ADDENDUM TRANSMITTAL

ADDENDUM TO THE CONTRACT DOCUMENTS	Page Number 1	No. of Pages 2
Addendum No. One (1)	Date Addendum Issued: Feb. 25, 2026	
Issuing Office Alaska State Parks, Design & Construction Section 550 W. 7 th Ave., Suite 1340, Anchorage, Alaska 99501 Phone: 269-8731 Fax: 269-8907	Previous Addenda Issued None	
Project: Old Kasilof Landing SRS Facility Host Site Project No.: 73032-2	Date and Hour of Quotes Due Mar. 4th, 2026 at 2:00pm prevailing time

WELL HOUSE PIPING & ELECTRICAL SCHEMATIC

OLD KASLOF LANDING SRS FACILITY HOST SITE PROJECT No. 73032-2

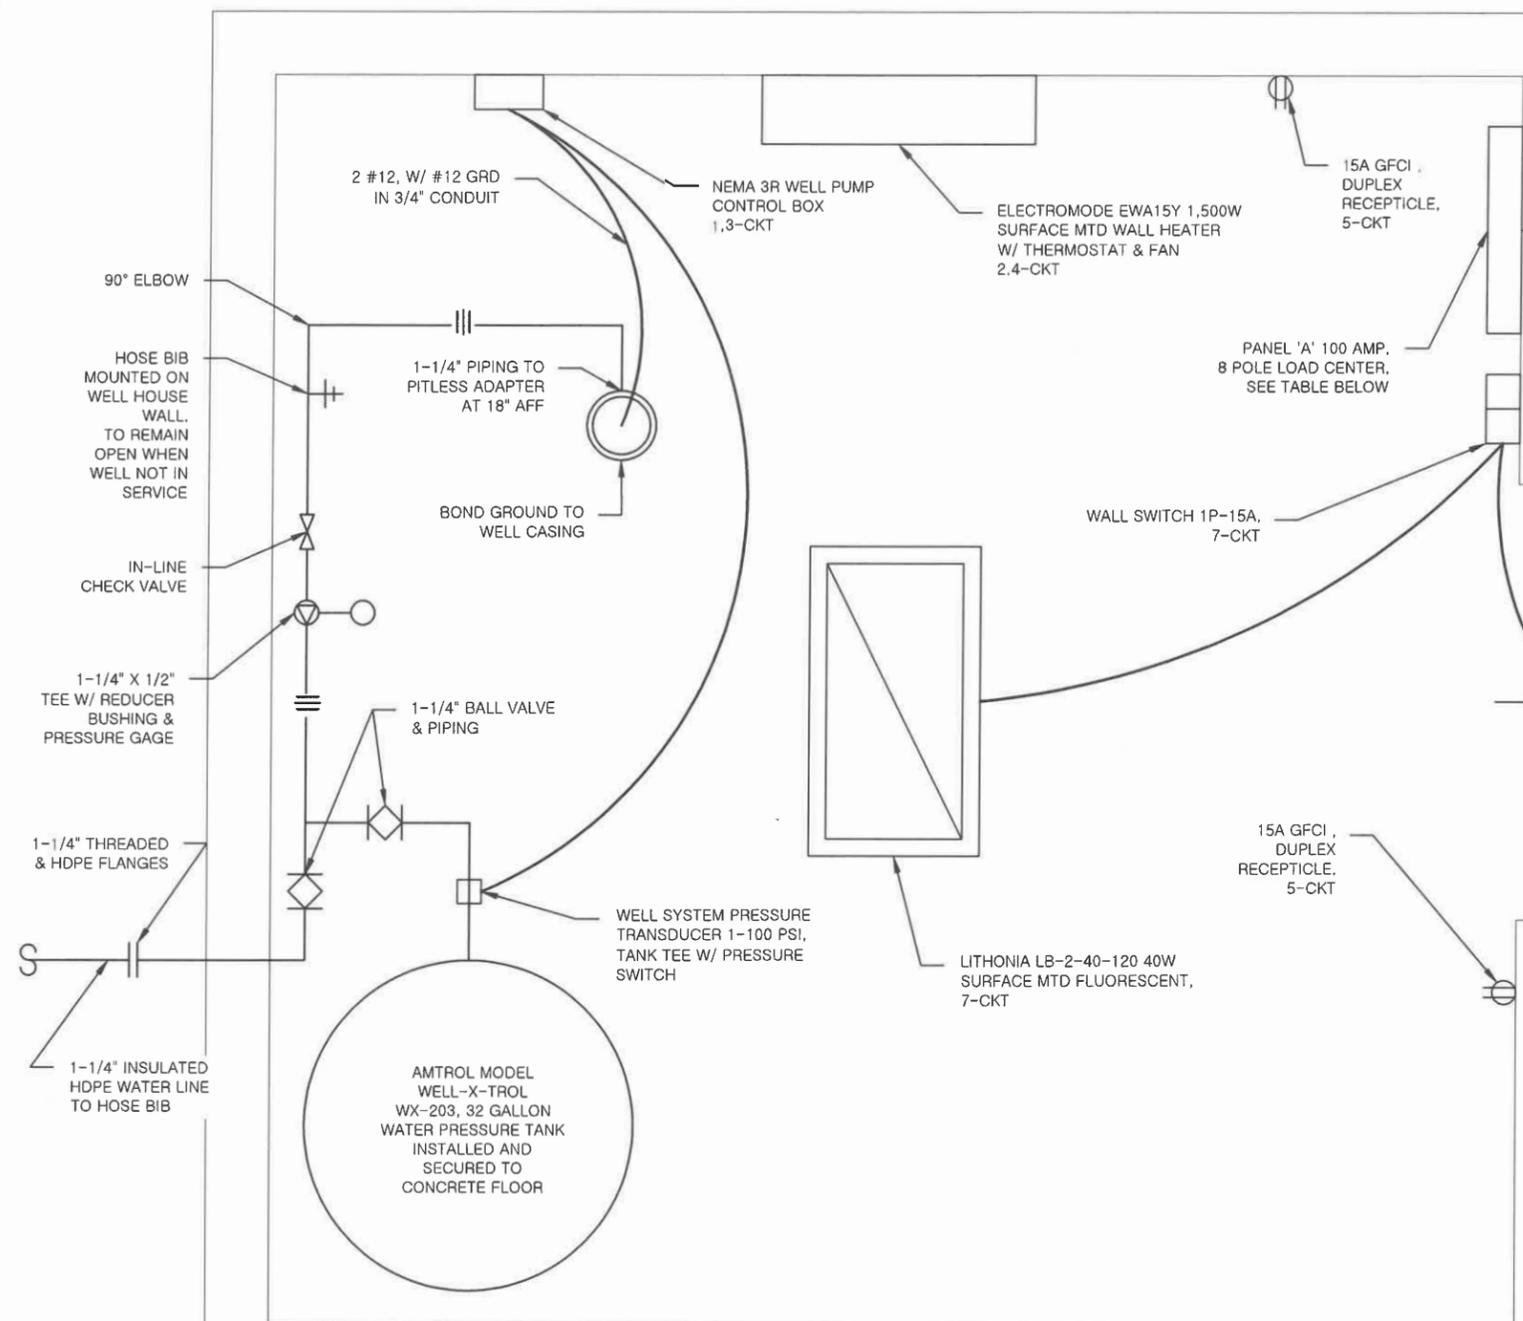
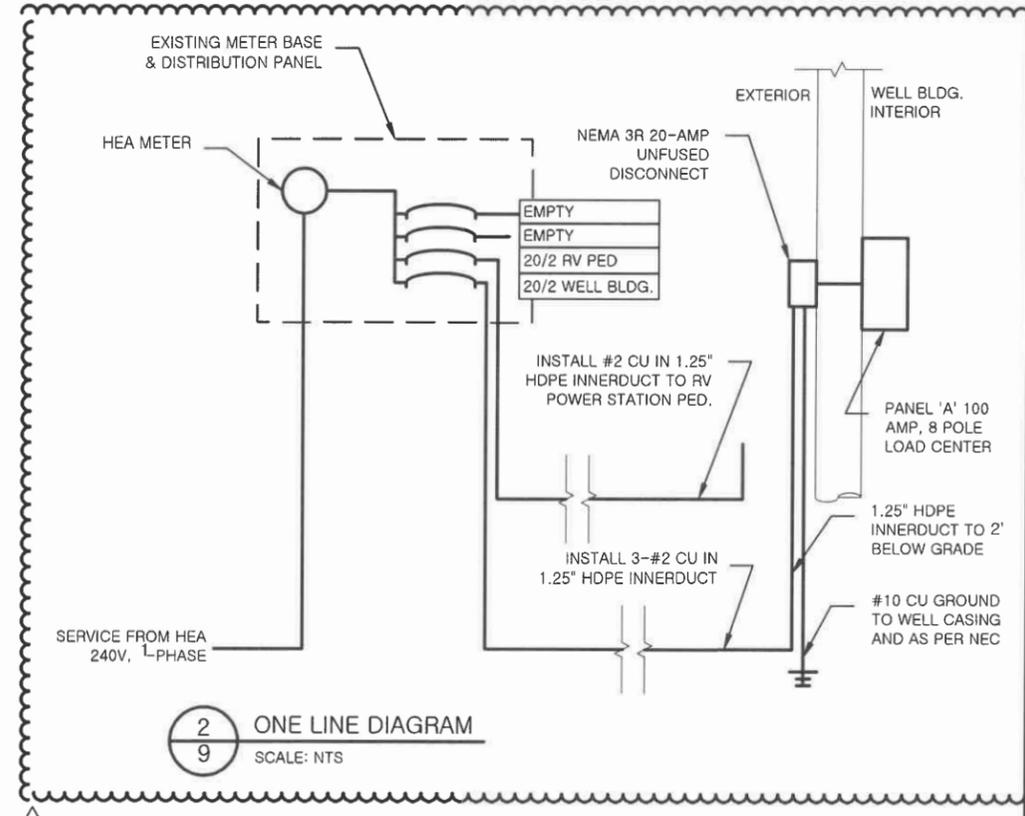
The intent of these changes is to provide clarity on the electrical work and wiring design, as well as alter the AWG of the primary runs downstream of the meter to account for voltage drop.

NO.	REVISION	DATE	NOTES
1	ADDENDUM 1	2/25/2026	CHANGES TO WIRING PLAN AND CLARITY
